Addendum 2

Client: Creswell School District
Project: CHS Academic Building Improvements (Primary) Project
Date: March 5, 2026
To: Interested Bidder
Prepared by: Curt Wilson, AIA; Principal, Wilson Architecture

This Addendum modifies the Project Manual, Specifications, and Drawings as follows:

1 DEMO FLOOR PLAN - AREA A
D1.10 1/8" = 1'-0"

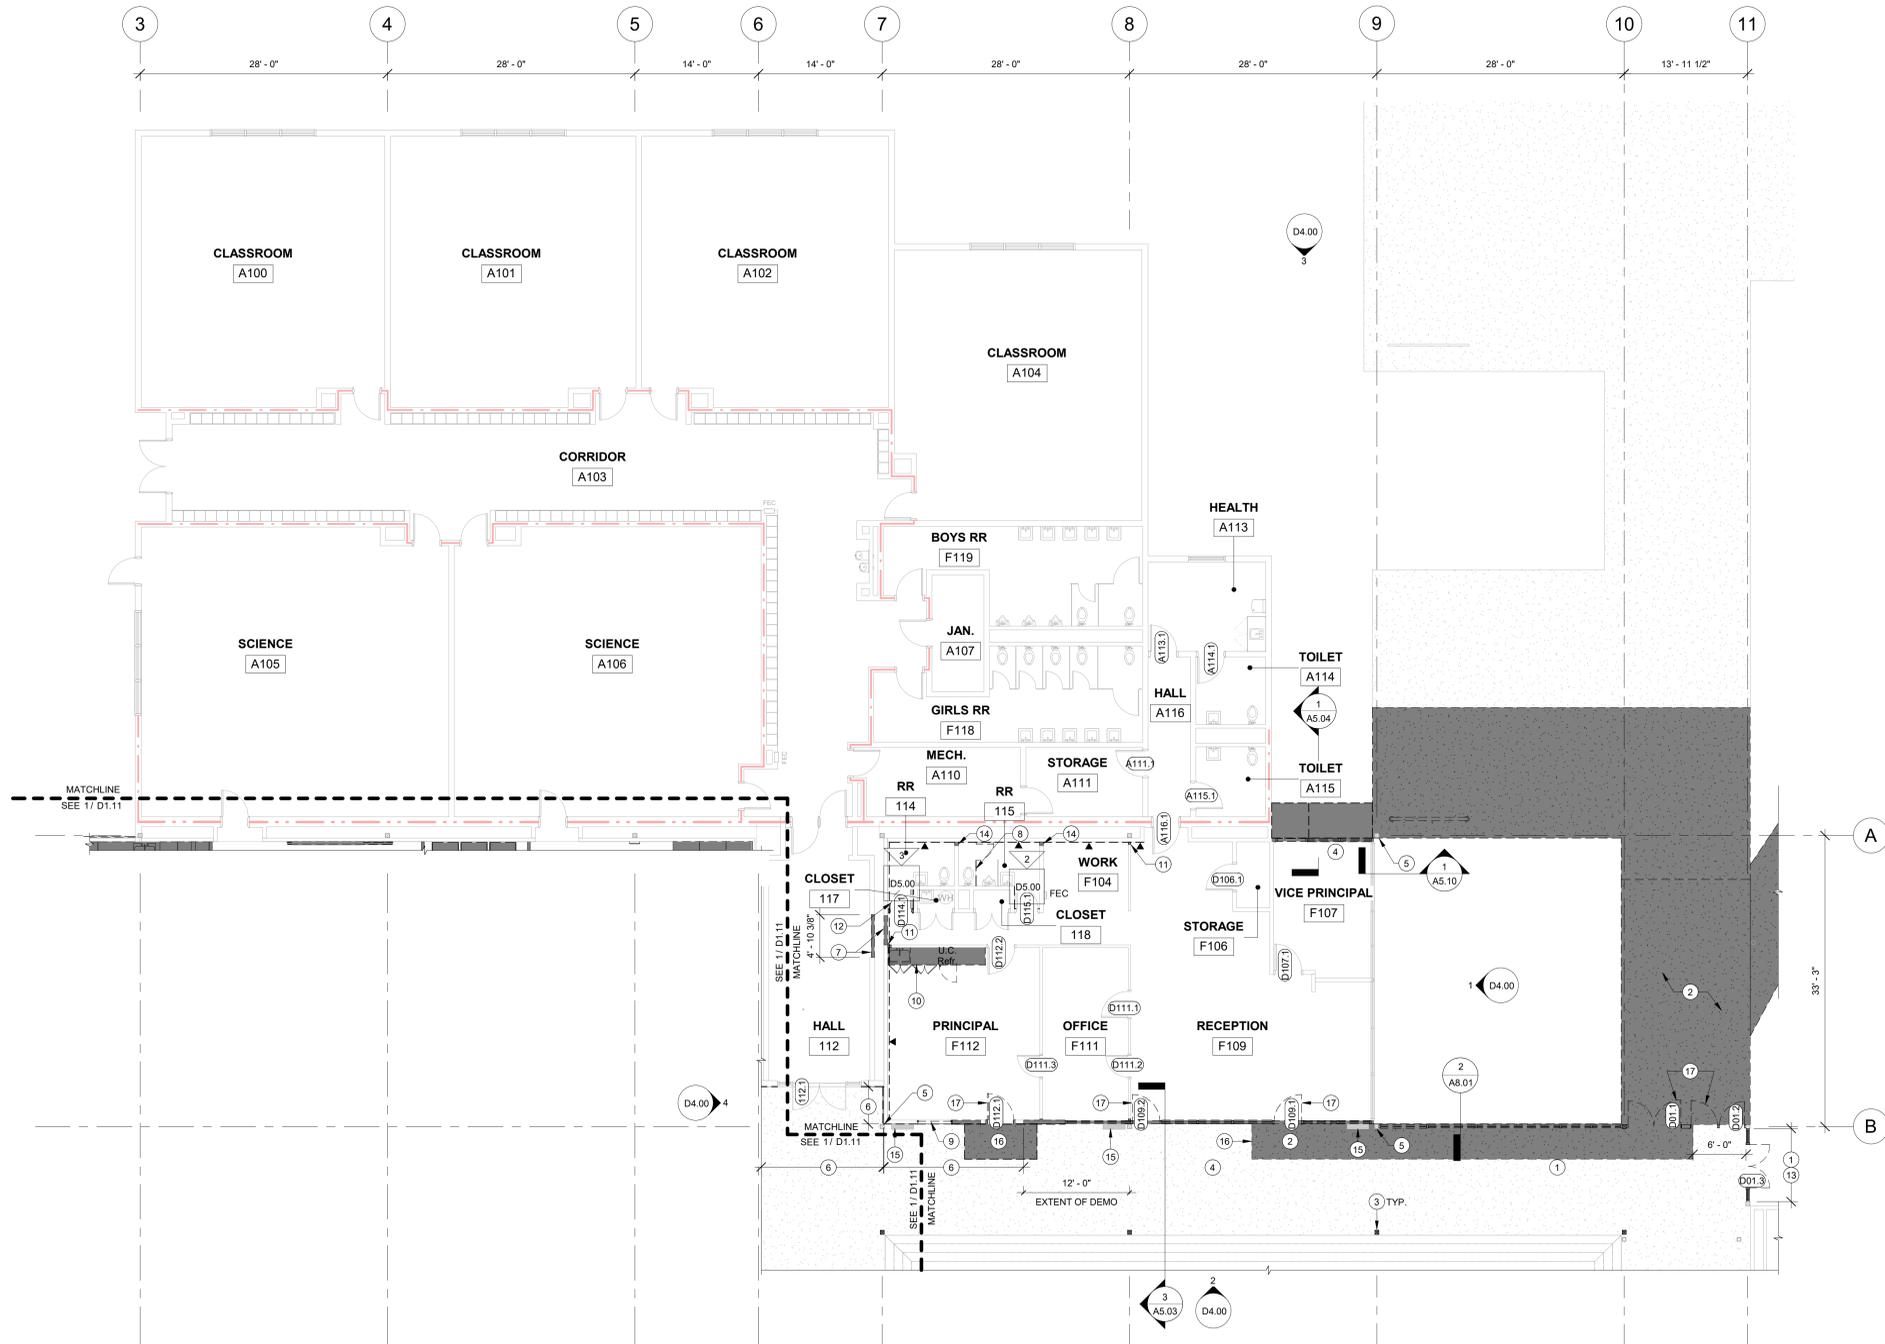
- Add wall assembly for higher STC rated wall.
 - Add Top of Wall and Floor assemblies.
 - 3.4. Sheet D1.10
 - a. Replace original sheet with attached version. A brief summary of the changes include:

- Demo notes revised as applicable to TI Project.
 - 3.5. Sheet D1.20

1 DEMO ROOF PLAN - AREA A
D1.20 1/8" = 1'-0"

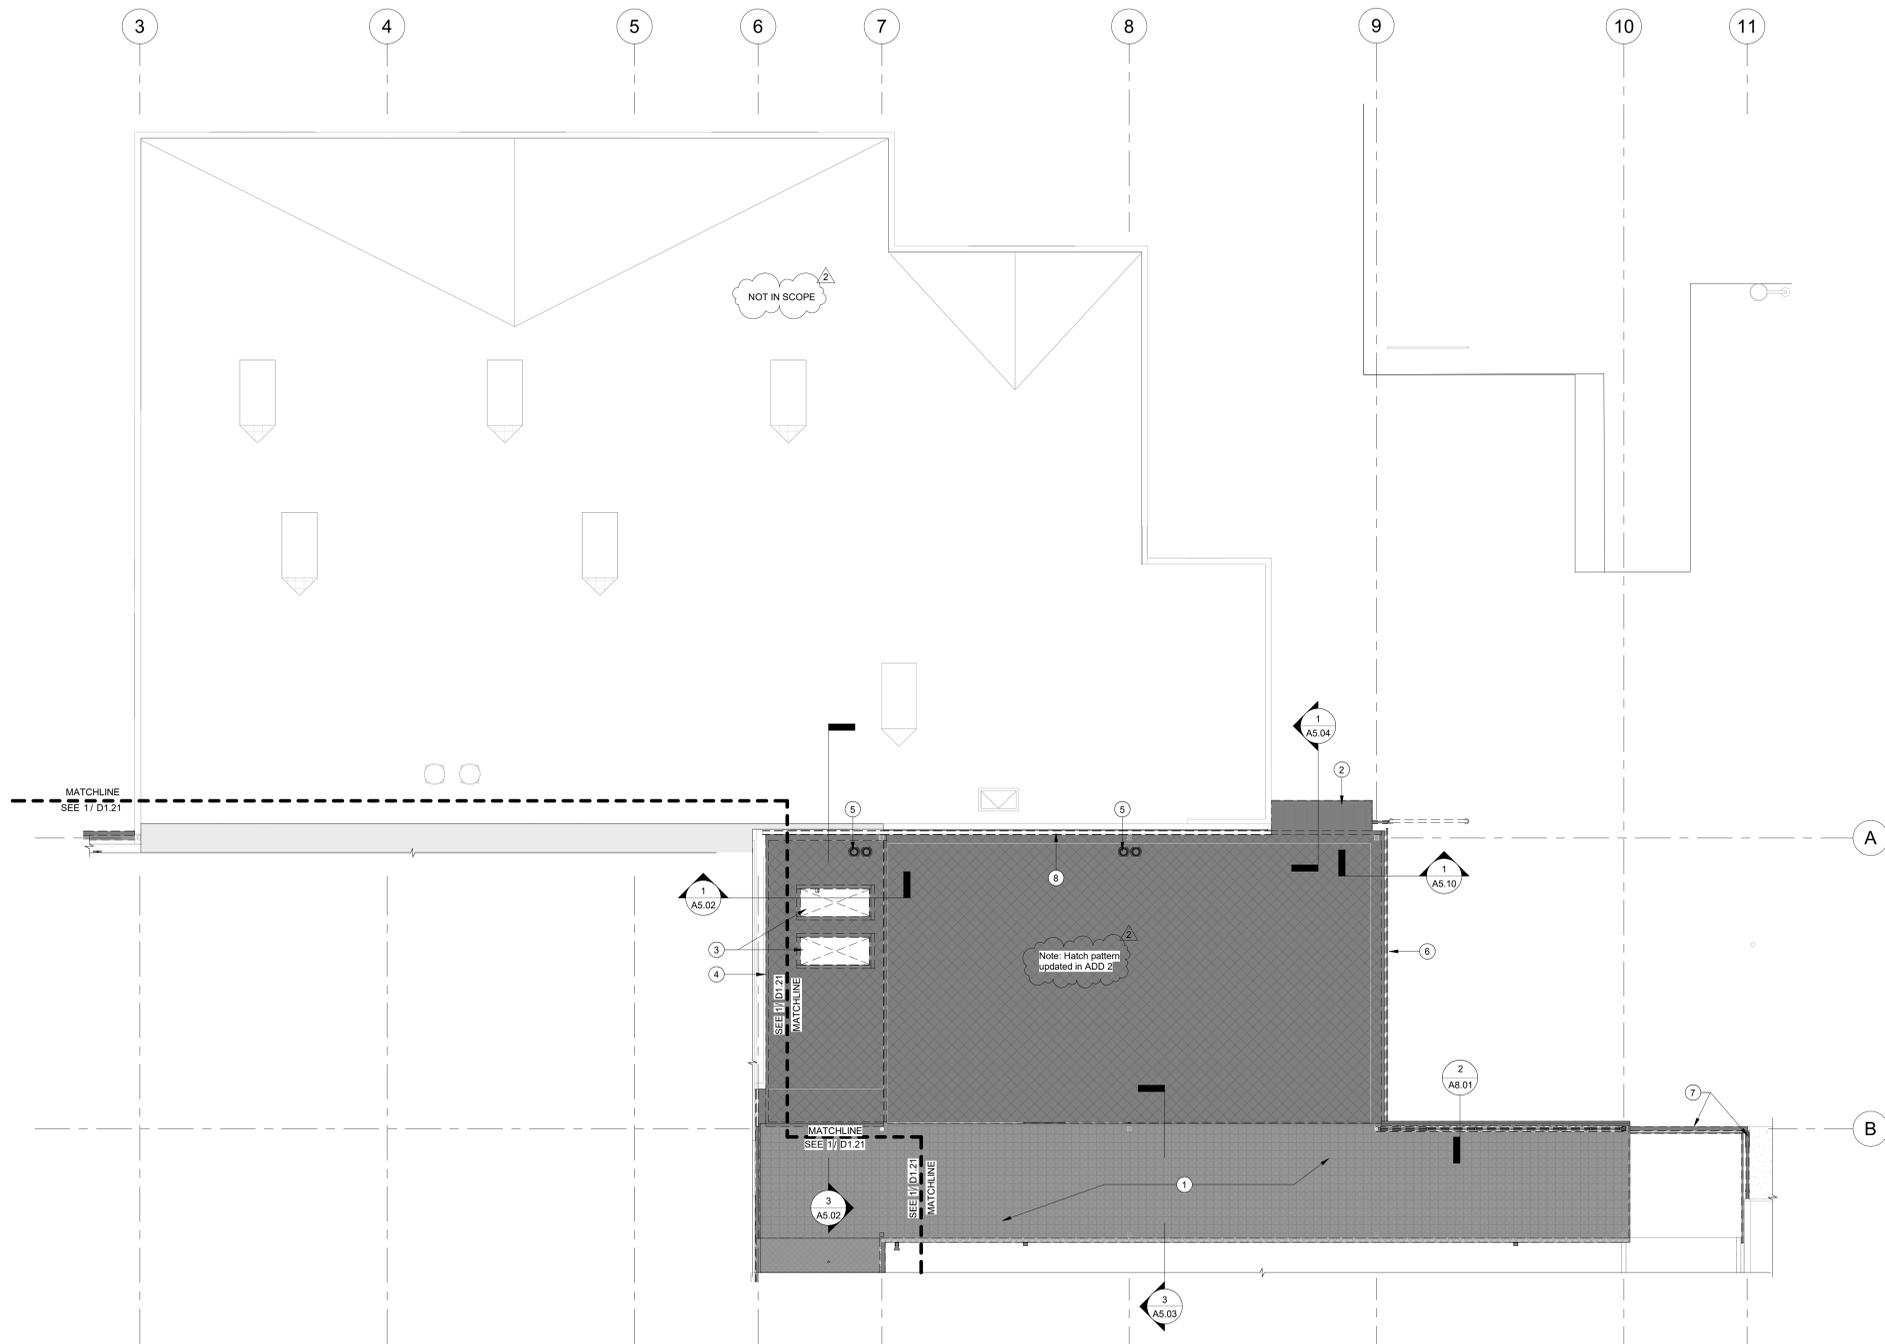
- a. Replace original sheet with attached version. A brief summary of the changes include:
 - Update roof hatch graphic.
- 3.6. Sheet A1.10
- a. Replace original sheet with attached version. A brief summary of the changes include:

1 SITE PLAN
A0.00 1" = 20'-0"

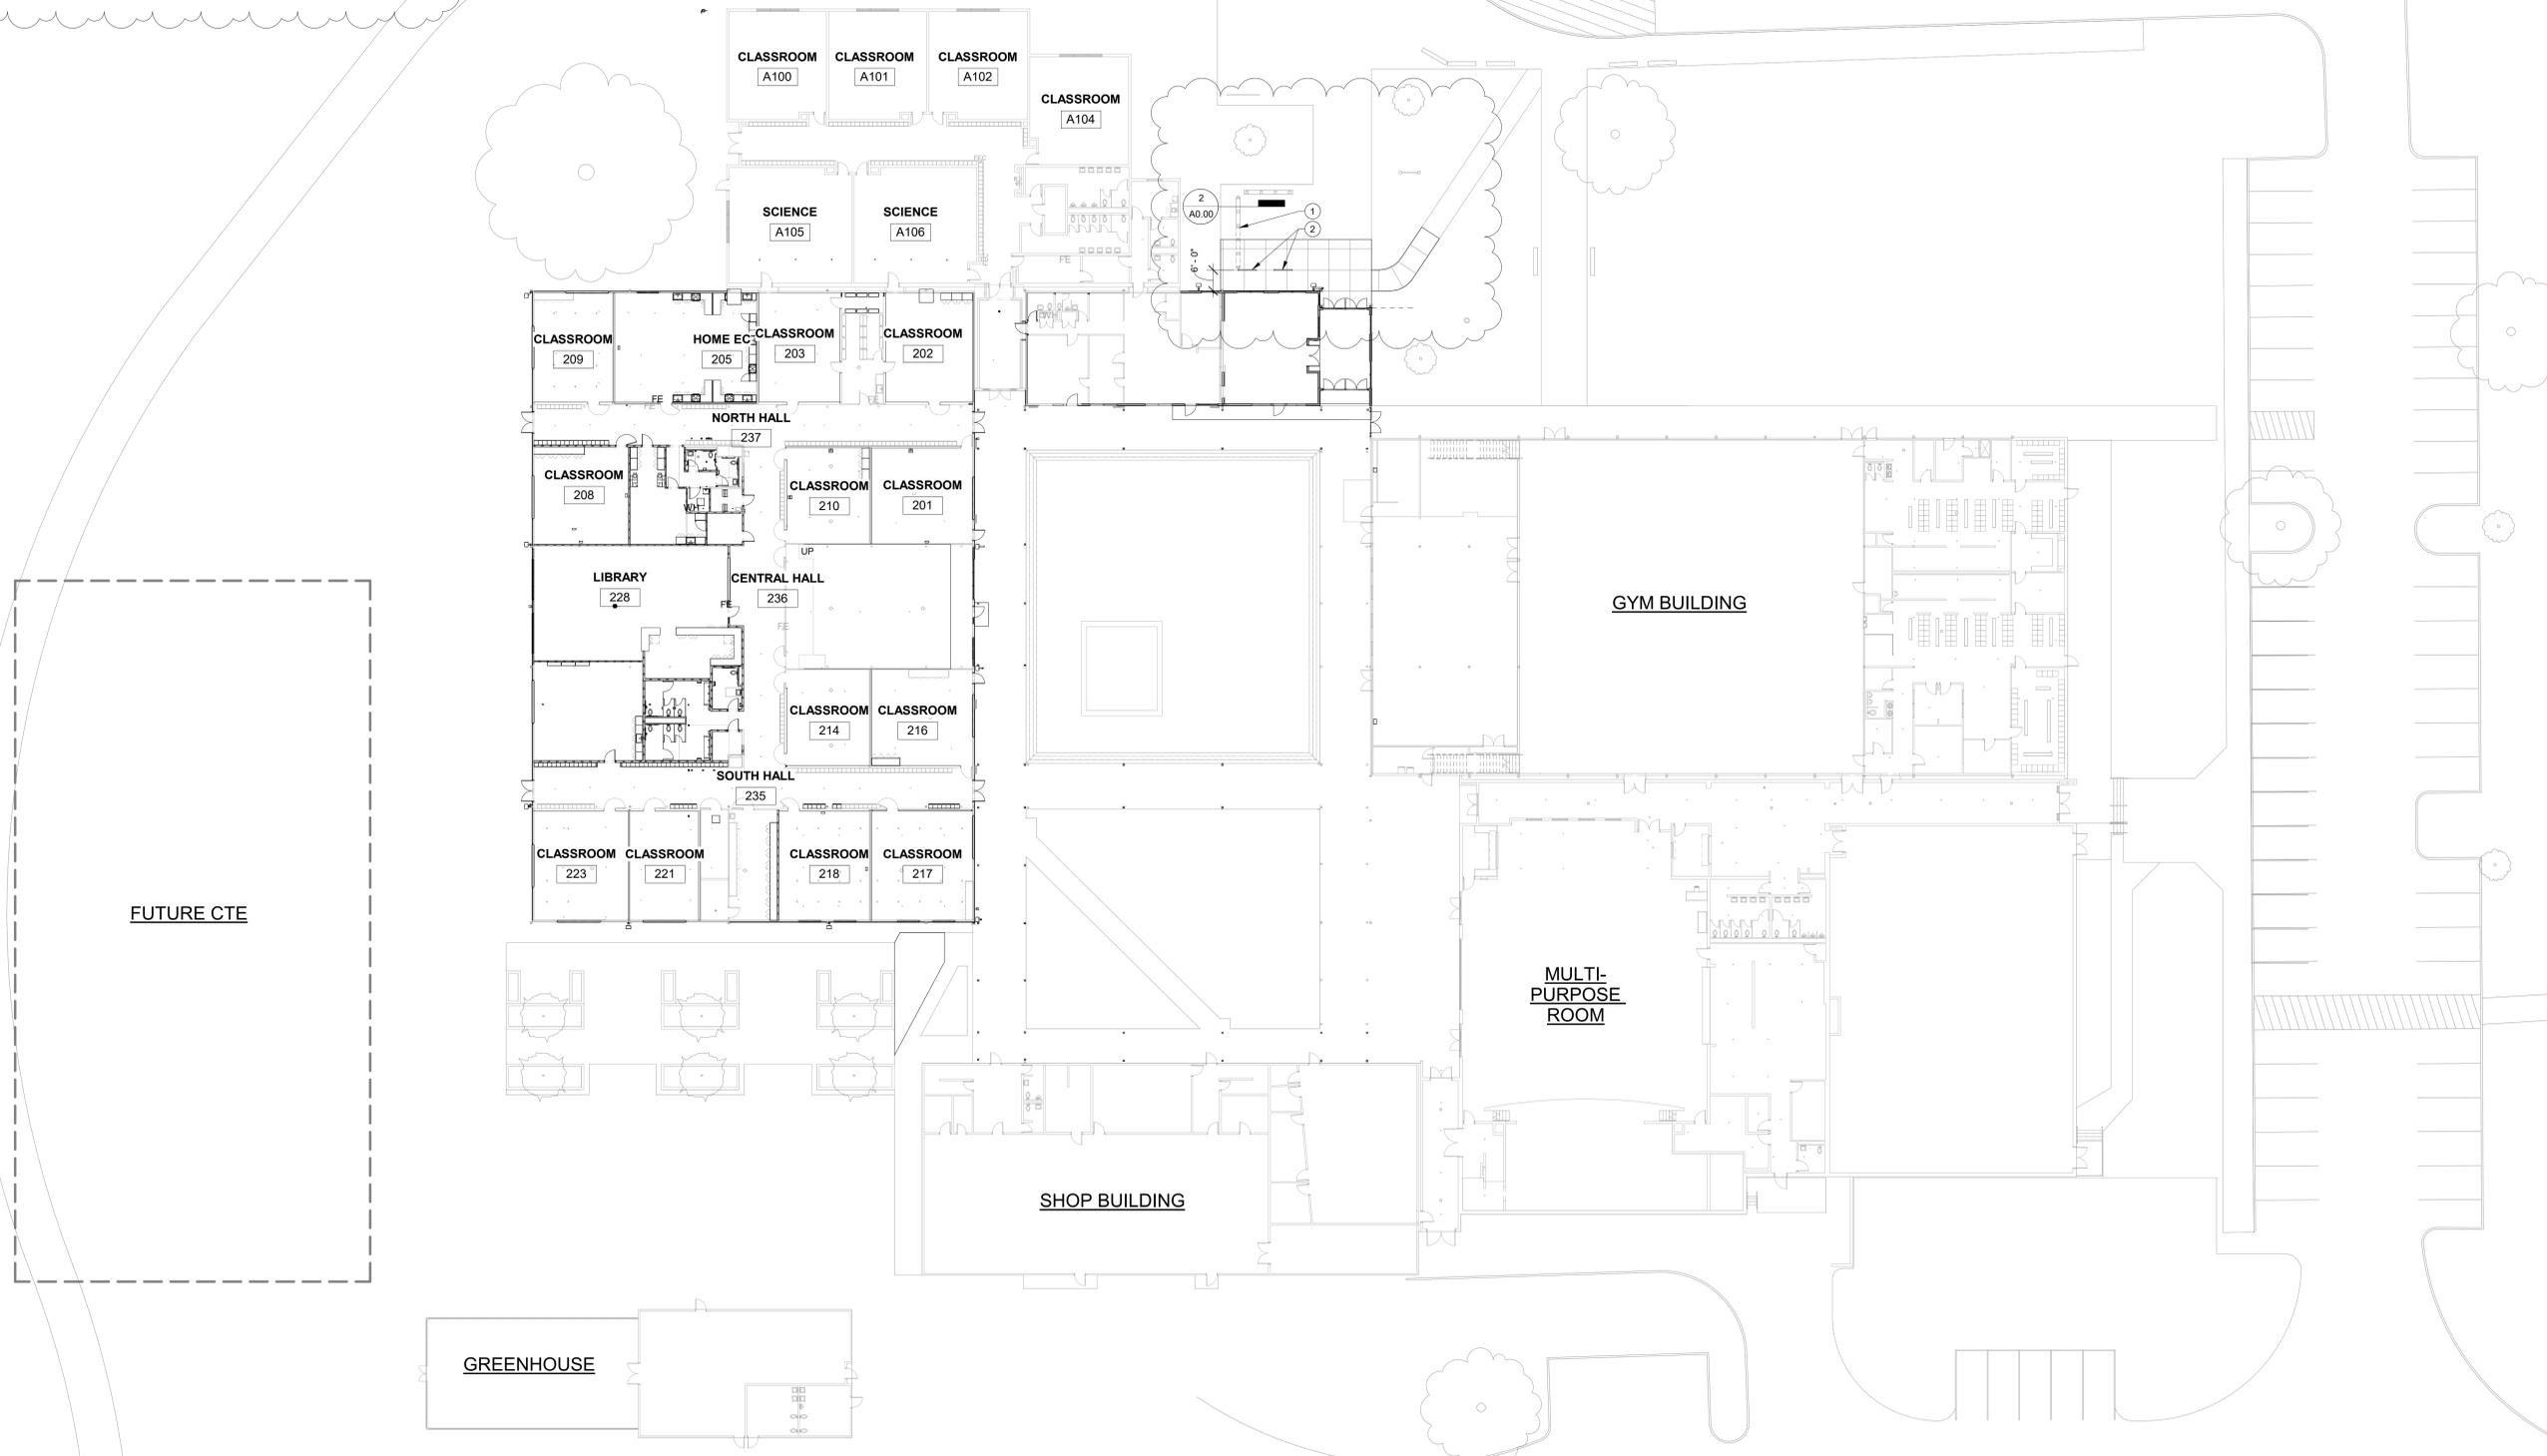
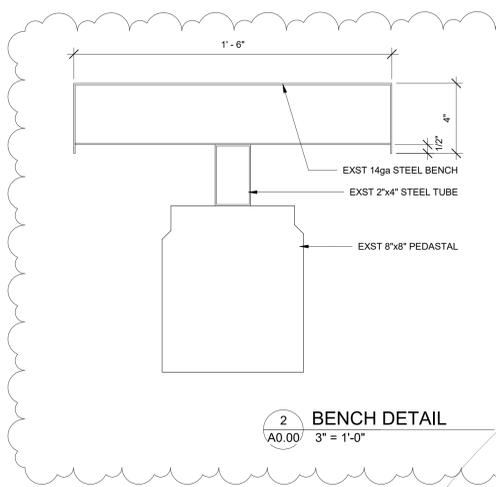
- 3.2. Sheet A0.00
 - a. Replace original sheet with attached version. A brief summary of the changes include:
 - Extent of sidewalk modifications adjusted to align with Civil.

- Existing bench to be modified
 - New bike racks
 - 3.3. Sheet A0.10
 - a. Replace original sheet with attached version. A brief summary of the changes include:

- BENCH TOP APPROXIMATELY 4" SOUTH OF THE THIRD CONCRETE PIER FROM THE NORTH. REMOVE SECTION OF BENCH AND CONCRETE PIERS SOUTH OF CUT LINE.
- *BIKE RACK MODEL # HW238-7-SF-P* BY BELSON OUTDOORS
